Docket 71-9251  
Model BW-2901

Subject: Additional information for the for the model BW-2901 Shipping Package  
Certificate of Compliance No. 9251

**Response to NRC Request For Additional Information  
Docket 71-9251  
Model BW-2901 Package**

**Figure 6-4**  
**Original Pellet Tray Model**

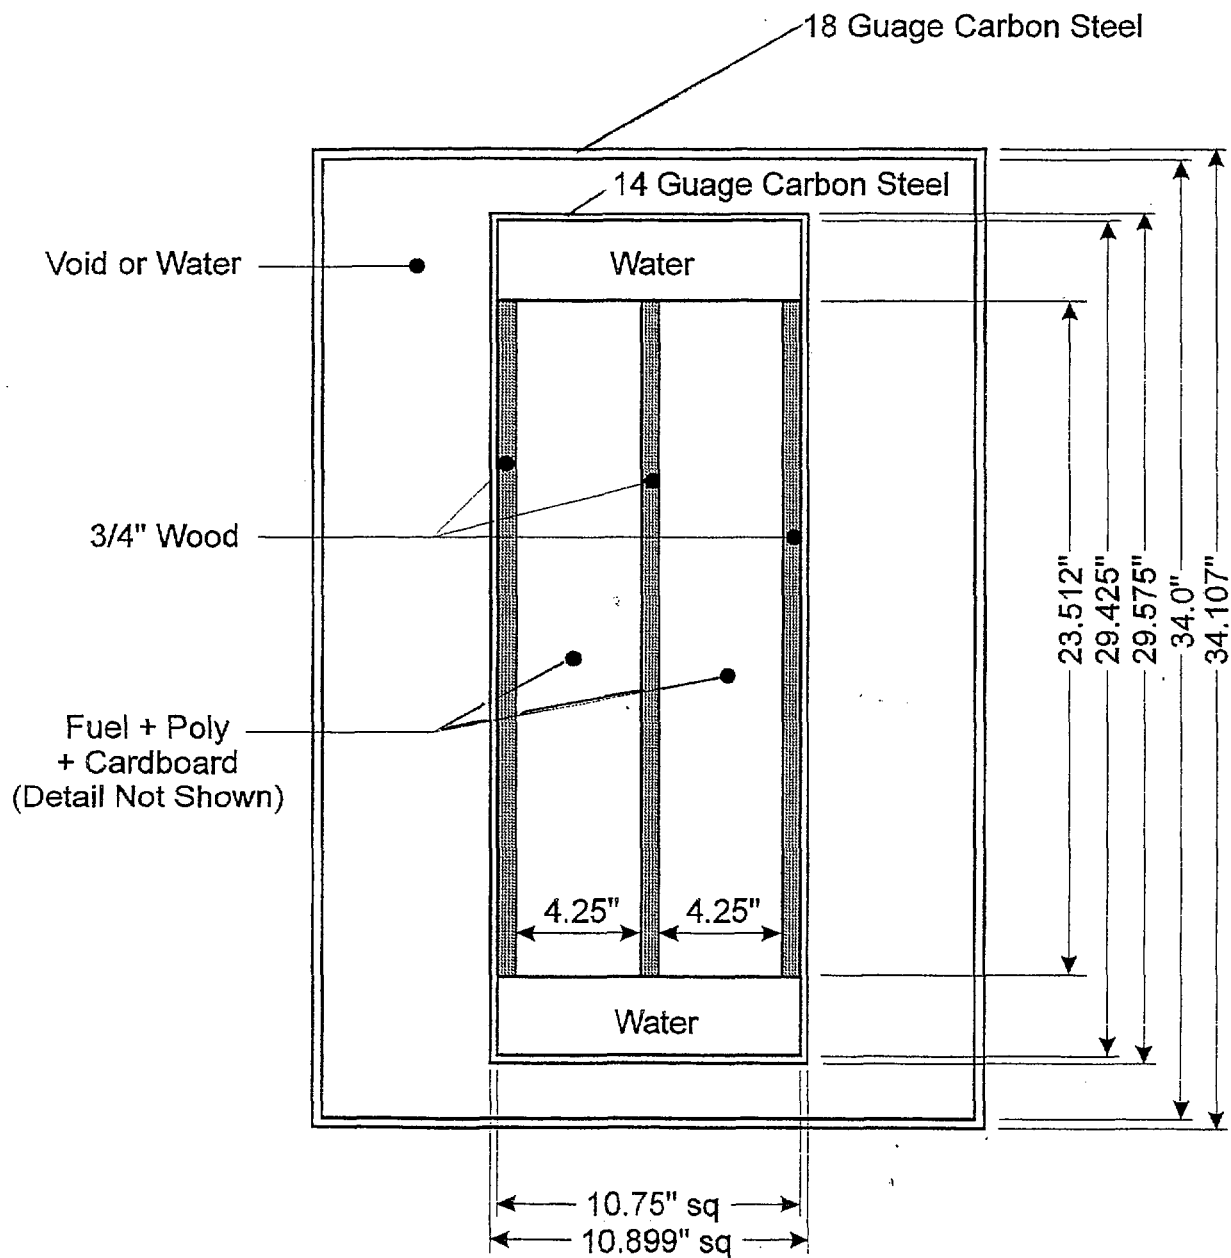
**Request:** Submit improved quality copies of the following figures from Chapter 6: Figures 6-4, 6-5, and 6-6 (which should be in color). The figures were not legible.

**Response:** Chapter 6, Figures 6-4, 6-5, and 6-6 have been revised for clarity.

vol. %.
Page 6-26	Remove and replace pages 6-26 with page numbered the same. Changed Grams Poly to <u>Grams Poly</u> .
Page 6-28	Remove and replace pages 6-28 with page numbered the same. Replaced volt with vol. % and iwt with 1wt.
Page 6-29	Remove and replace pages 6-29 with page numbered the same. Replaced volt with vol. %.
Page 6-31	Remove and replace pages 6-31 with page numbered the same. Corrected U235.
Page 6-33	Remove and replace pages 6-33 with page numbered the same. Replaced a with $\sigma$ .
Page 6-35	Remove and replace pages 6-35 with page numbered the same. Changed UOZ to UO <sub>2</sub> .
Page 6-39	Remove and replace pages 6-39 with page numbered the same. Changed LRS to LRC and added +/- sign.
Page 6-41, 6-42, 6-43 and 6-46	Remove and replace pages 6-41, 6-42, 6-43 and 6-46 with pages numbered the same. Fix editorials RENO to KENO and R-effectives to K-effectives.
Page 6-82, 6-83, 6-84, and 6-85	Remove and replace pages 6-82, 6-83, 6-84, and 6-85. This change replaces figures 6-4, 6-4a, 6-5 and 6-6 with more vivid figures and color where applicable.
